From: Curtis, Jeff <Jeff.Curtis@safety-kleen.com>
Sent: Friday, February 07, 2014 11:46 AM
To: Russell, Merlin
Cc: White, John; Bahr, Tim; Tripp, Anthony; Echevarria, Edgar
Subject: RE: "SK Sanford"
Attachments: Part I. B page 1.pdf; Annotated Figure 2 2-1.pdf

Attached is revised figure 2.2-1 along with a revision to the text discussing surface water – Part I.B, page 1.

FIGURE 2.2-1
TOPOGRAPHIC MAP
SAFETY-KLEEN SYSTEMS, INC.
SANFORD, FLORIDA

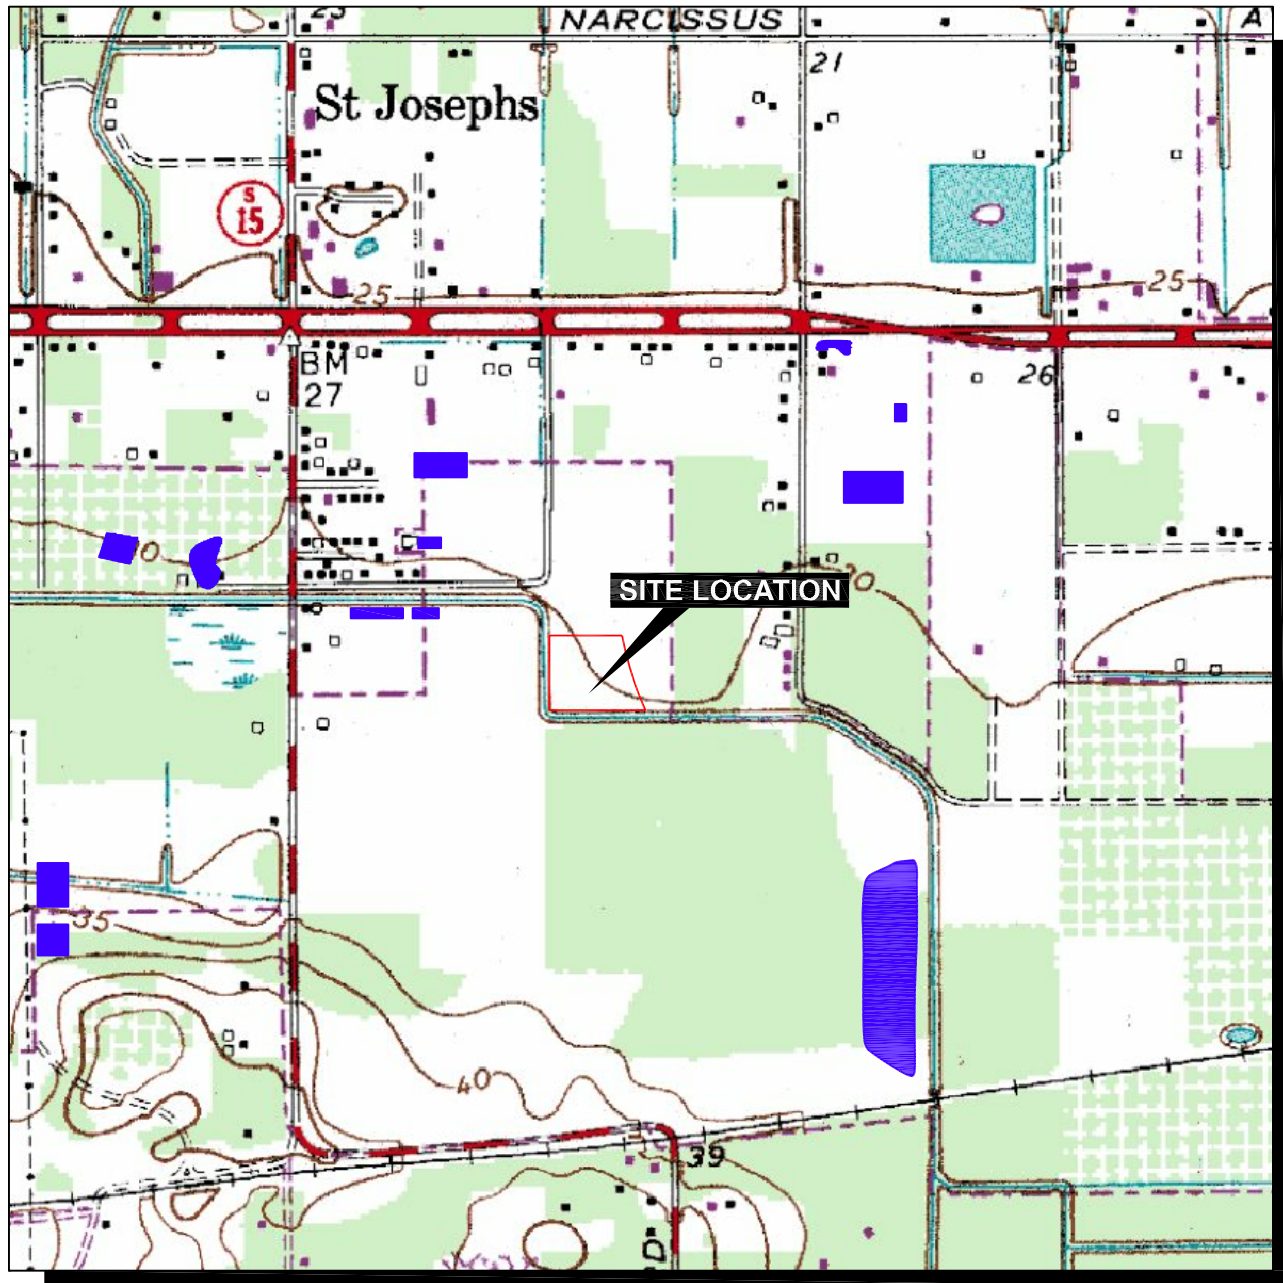
ANNOTATED STORMWATER PONDS
(Man-made features added after 1988 -
locations are approximate)

Surface water bodies located within one-quarter mile of the facility property boundary include Smith Canal, which runs along the western and southern boundaries of the site, as shown in Figure 2.2-1. Since the last photo revision of the Sanford Quadrangle map in 1988, development in the area has resulted in many man-made stormwater retention ponds being constructed in the vicinity of the site. These figures have been added onto Figure 2.2-1 based on manual annotation from publically available aerial photography of the site vicinity. The locations and shapes are approximate.
